# Service Bulletin

<b>Subject</b>	<b>Note when releasing the paper jam/maintaining the machine (Prohibition of use of the flammable sprays and liquids)</b>
<b>Model</b>	All models

<b>Subject</b>	<b>Mac OS 10.7 Lion: Alternative Scan Function since Scan to SMB is NO LONGER supported in the Latest Mac OS Version</b>
<b>Model</b>	<b>All MFP Models</b>

<b>Subject</b>	<b>Change since the 1st mass production*</b>
<b>Model</b>	<b>TASKalfa 2550ci</b>

<b>Subject</b>	<b>CF card attaching/detaching operation improvement</b>
<b>Model</b>	<b>TASKalfa 2550ci</b>

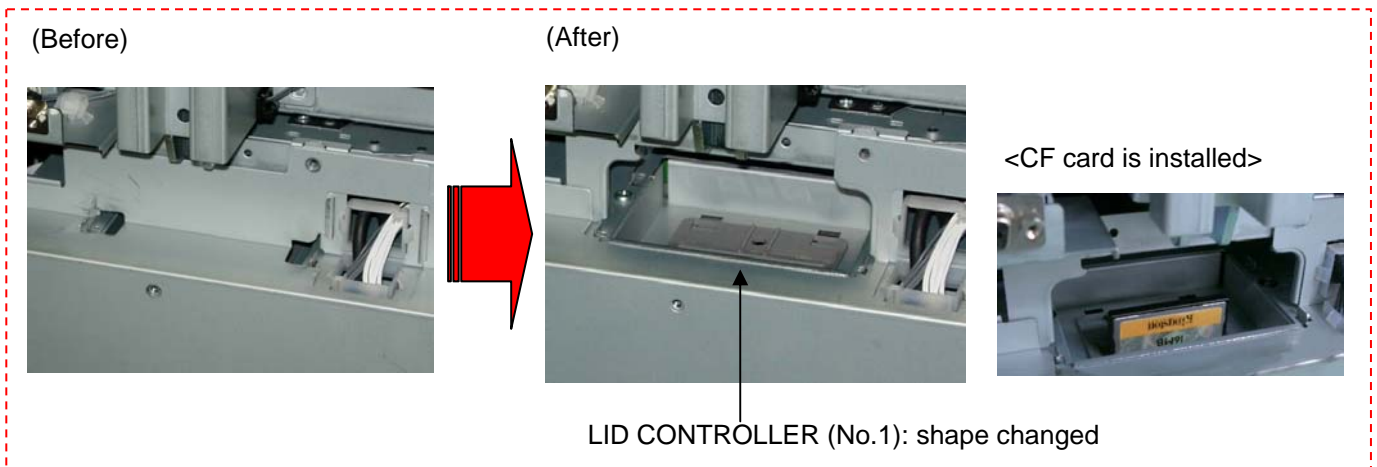
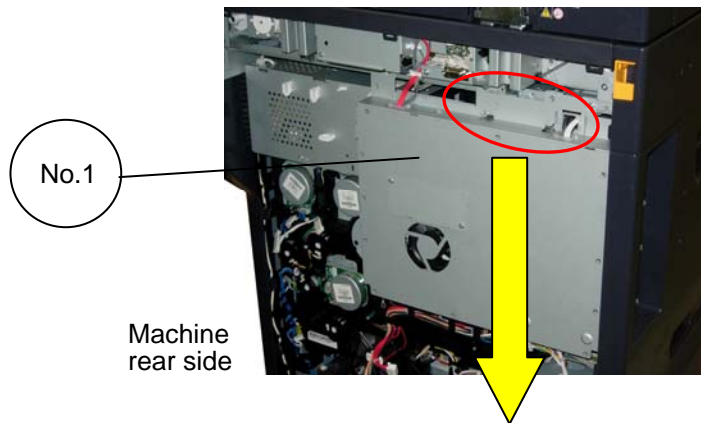
The shape of LID CONTROLLER (No.1) on the controller box is changed as follows to make it easy to attach and detach a CF card. The CF card can be attached and detached without removing LID CONTROLLER (No.1) after this change.

**<Prevention of the clip holder coming off --> Planned in May, 2012 production >**

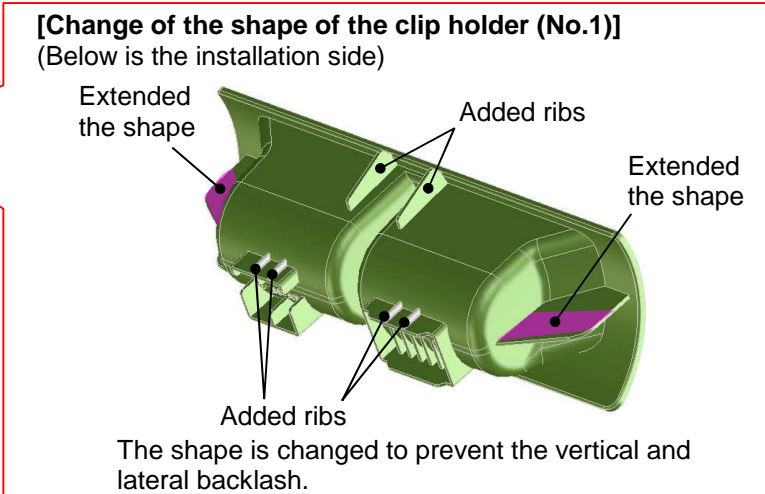
The shape of the clip holder (No.1) is changed as below for preventing the clip holder from coming off due to the vibration in transit, etc.

This convex part prevents the clip holder (No.1) from coming off before this change.

**--> After using up the old stock>**

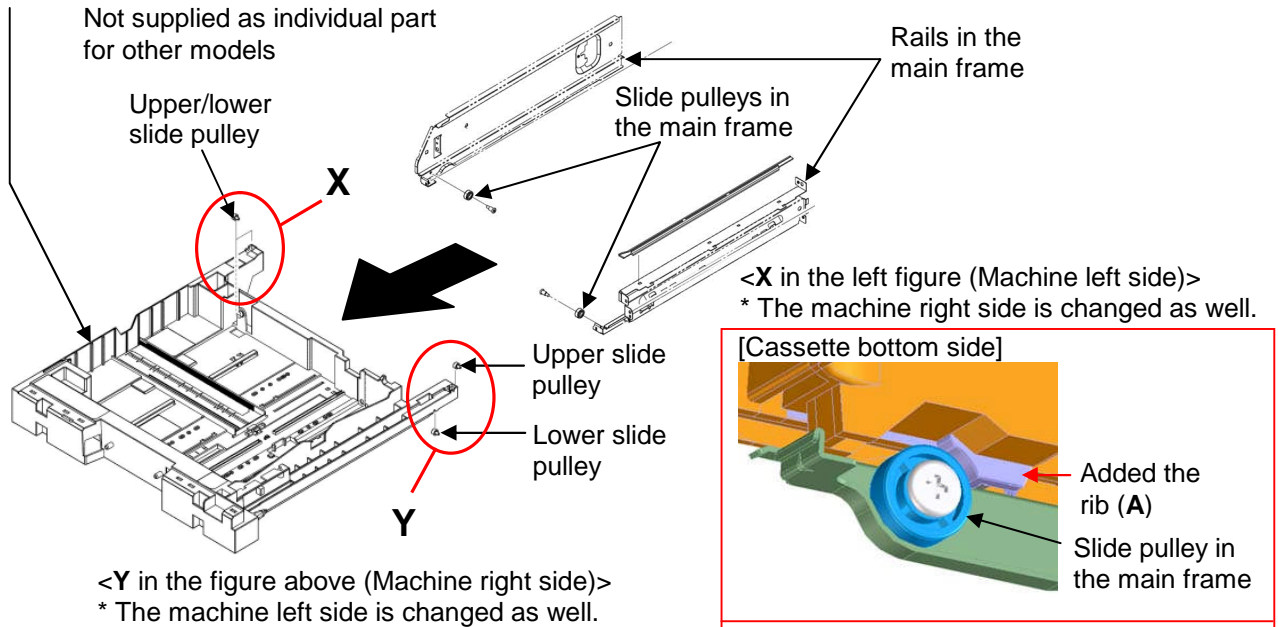
The shape of the cassette is changed as below to improve the operability when pulling out the cassette.

- 1) To secure the cassette after pulled out, the rib (A) for contacting the slide pulleys in the main frame is added to the attaching part for the upper slide pulley at the cassette bottom side.
- 2) To prevent the horizontal backlash when pulling out the cassette, the rib (B) is added to the cassette side.
- 3) To secure the gap between the rail in the main frame and the side of the upper slide pulley, the rib (C) for contacting the rail is added to the attaching part for the upper slide pulley.

**[FIG. 6 MAIN FRAME PARTS ASSY 3]**

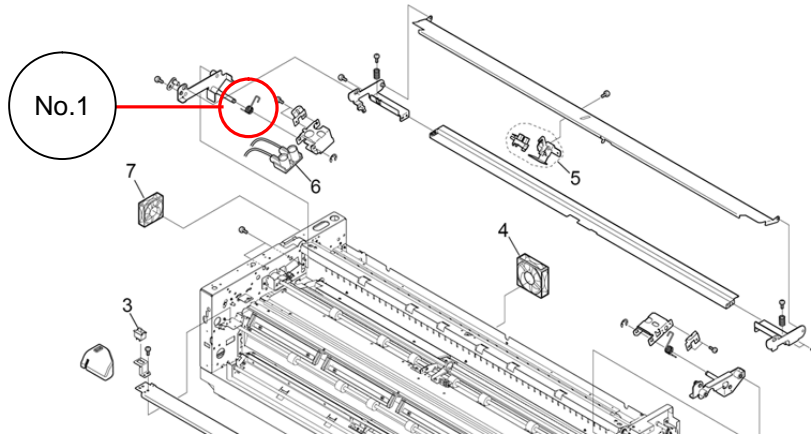
The parts numbers is set to the following spring (No.1).

<b>Subject</b>	<b>Notes when replacing the rear cover</b>
<b>Model</b>	<b>TASKalfa 2550ci</b>

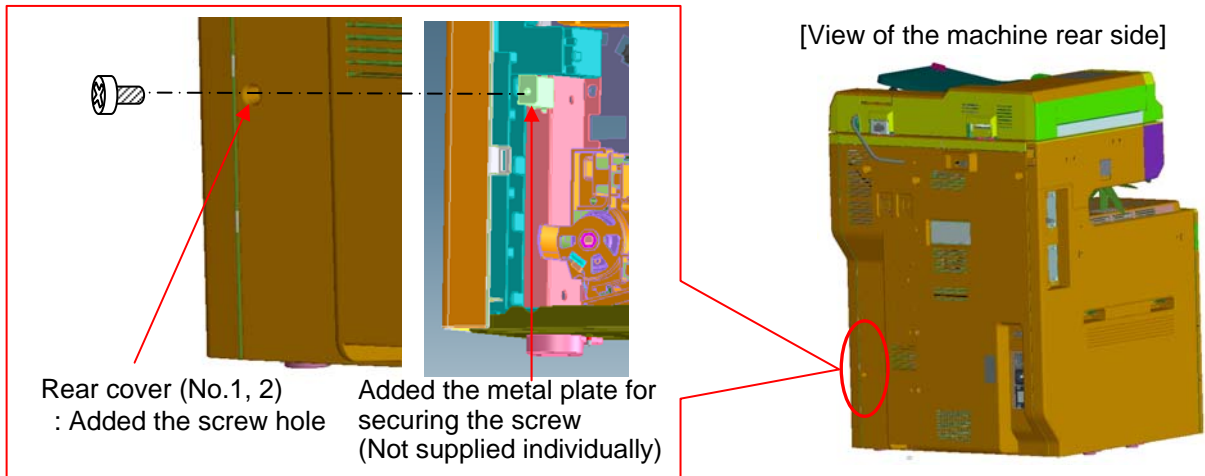
An attention is required when replacing the rear cover according to this change, and refer to [Field Measure].

Please affix the seal covering the hole (No.3) after cleaning the bottom of the screw hole added this time with alcohol when fitting the new rear cover (No.1, 2) in the machine before this changes (without the metal plate for securing the screw).

**Field Measure:** When fitting the new rear cover (No.1, 2) in the machine before the above changes, please clean the bottom of the hole added this time with alcohol, and affix the seal covering the hole.

**--> From the available timing in the production in July, 2012>**

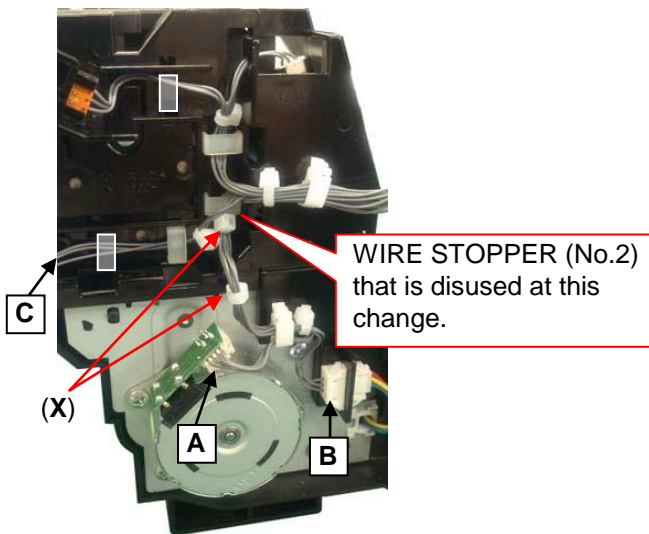
The wire alignment is changed by the following change for the easy wire alignment work of WIRE EXIT (No.1) at the exit unit.

**<Strengthening the conveying guide D2 --> After using up the old stock>**

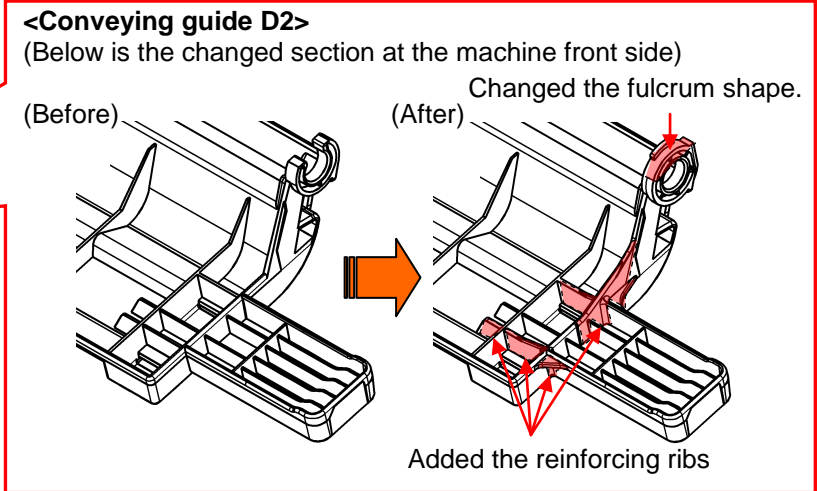
The shape of the conveying guide D2 (No.1) is changed for strengthening.

**<COVER LEFT LOWER (No.2)>**

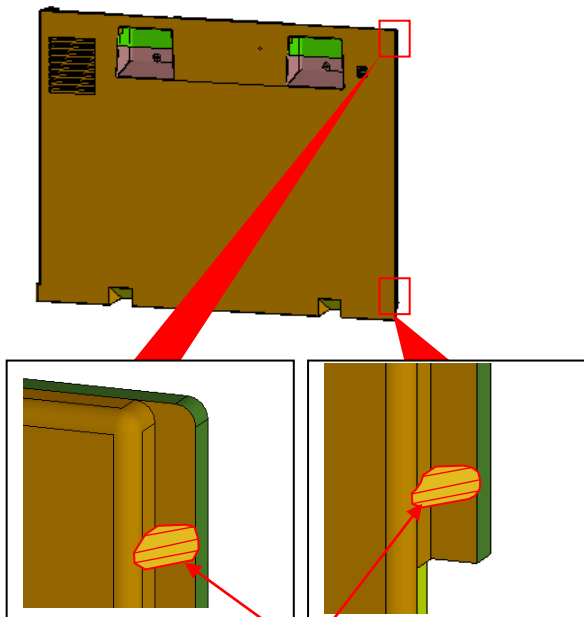
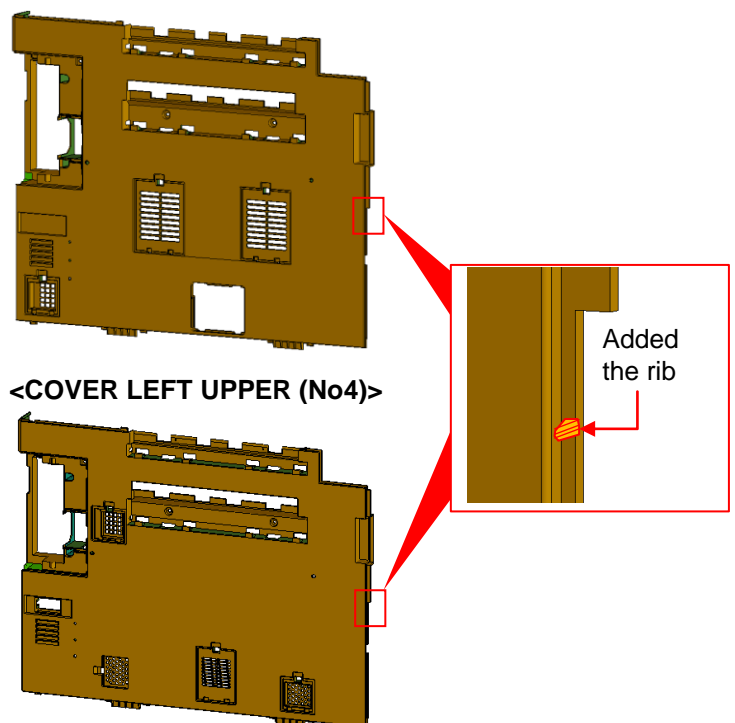
Added the ribs
